New digital advertising sign – Windsor Road M2 Overpass, Baulkham Hills

Development application assessment report (DA 23/2901 or PAN-310932)

August 2023

Published by the NSW Department of Planning and Environment

Figure 9 | Proposed anti-gawk screen (Source: Applicant's SEE)

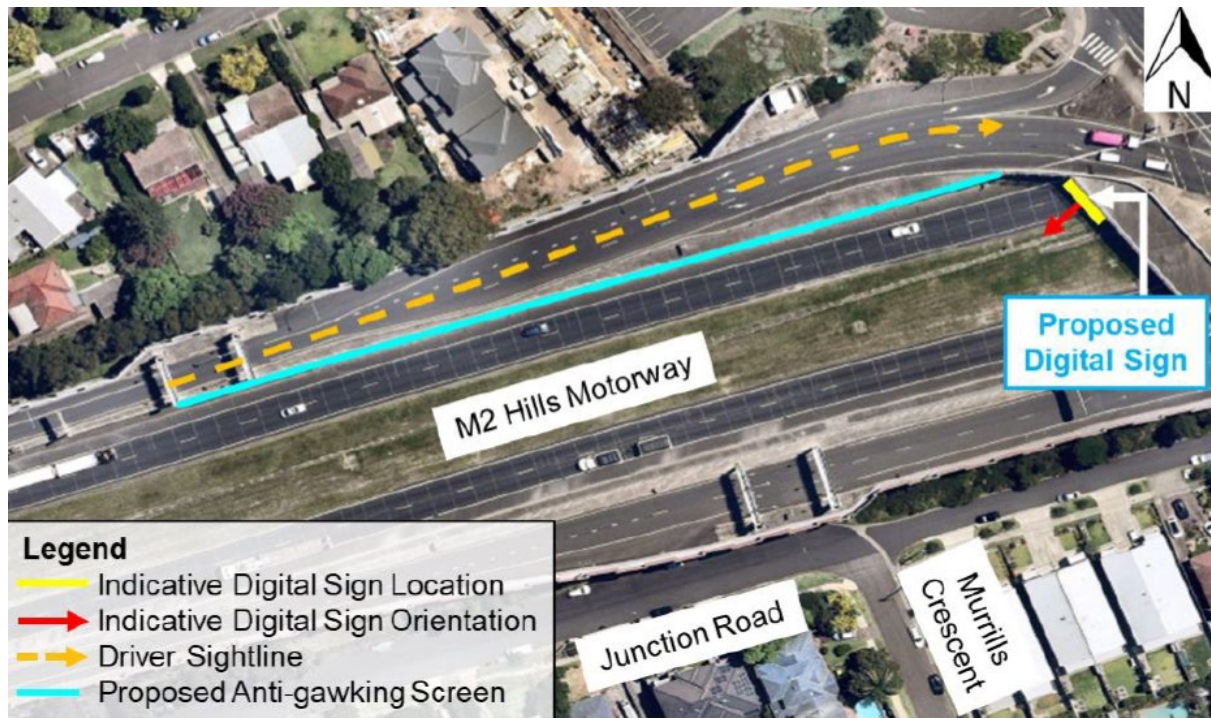
In June 2023, the Applicant submitted additional information to the Department including a request that the proposed anti-gawk screen no longer apply to the application. In response, TfNSW issued revised concurrence and its general terms of approval confirming that the anti-gawk screen was necessary and the Applicant must prepare a plan for the screen and a supplementary road safety audit for TfNSW's review and approval.

Figure 10 | Concept design of the anti-gawk screen (Source: Applicant's additional information)

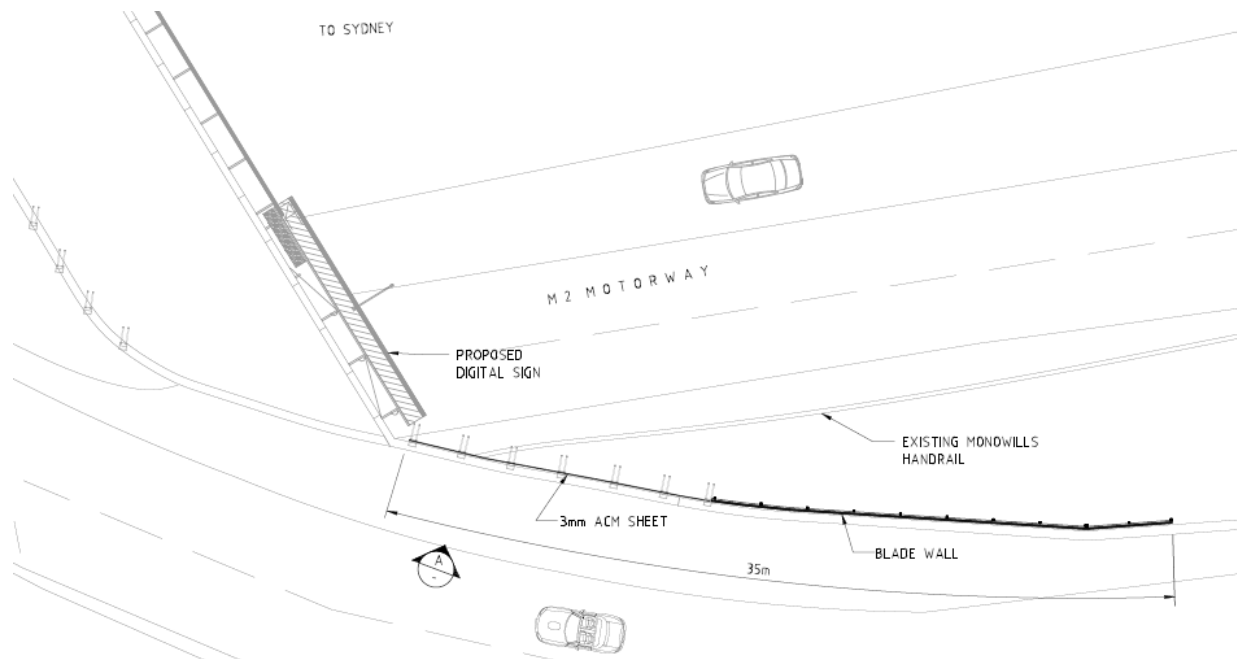
The Department requested that the Applicant respond to the above submissions, and provide additional information, including whether there was any crash data for the existing sign on the eastern façade of the overpass, and the intended planning pathway for the anti-gawk screen that is required to screen the proposed sign.

The Applicant lodged a response confirming that no crash data existed for the existing sign on the eastern façade of the overpass and requested that the anti-gawk screen be removed from the application. A response from the Applicant's traffic engineer (Bitzios) confirmed that while the DA as lodged and exhibited did propose an anti-gawk screen, their further investigations indicated that the likelihood of possible views to the sign from the off-ramp location were remote.

As discussed in **Section 5.1**, TfNSW's final concurrence reaffirmed the need for anti-gawk screen.

TfNSW reviewed the response to submissions information and issued further concurrence on 12 July 2023. The revised concurrence confirmed that drivers in the outside lane on the eastbound off-ramp to Windsor Road would have clear visibility to the proposed sign without having to turn their head, which

has the potential to create a potential distraction at this driver decision making point (i.e. signalised intersection of Windsor Rd/M2 interchange). To address the above potential road safety hazard, TfNSW requires the Applicant to install the anti-gawk screen.

On 26 July 2023, the Applicant subsequently submitted a concept design for the anti-gawk screen (see **Figure 10**).

As detailed in **Section 5.1**, the final design and installation of the anti-gawk screen will occur in consultation with TfNSW.

The Department recommends that TfNSW's general terms of approval are imposed in the consent. The Department also recommends a condition that the anti-gawk screen be designed in consultation with TfNSW and installed prior to the operation of the sign, and that the anti-gawk screen must remain in place for the duration of the sign's operation.
